MUNICIPALITY OF ANCHORAGE

Traffic Department

MEMORANDUM

RE: Revision to MOA School Area Traffic Safety Manual

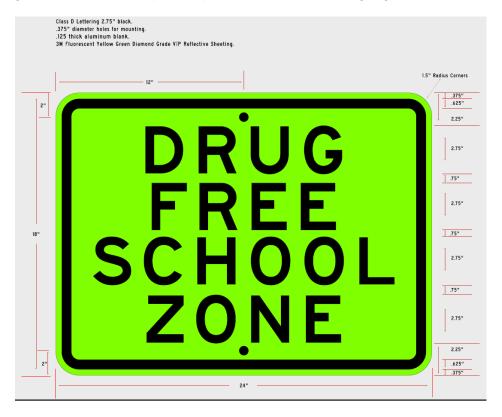
Effective 1 November 2019, Appendix "D" of the <u>School Area Traffic Safety Manual</u> dated March 2017 is amended to change the following sign.

The Drug Free School Zone sign (A-S6-100) is no longer valid for use on private or public projects or school zone signage.

The S6-200_A Drug Free School Zone sign, as shown in the image in this Memorandum, will be the default sign when called for in plans, specifications and new signage installations.

The sign shall consist of 2.75 inch black Class "D" letters on a fluorescent yellow-green Diamond Grade VIP sheeting.
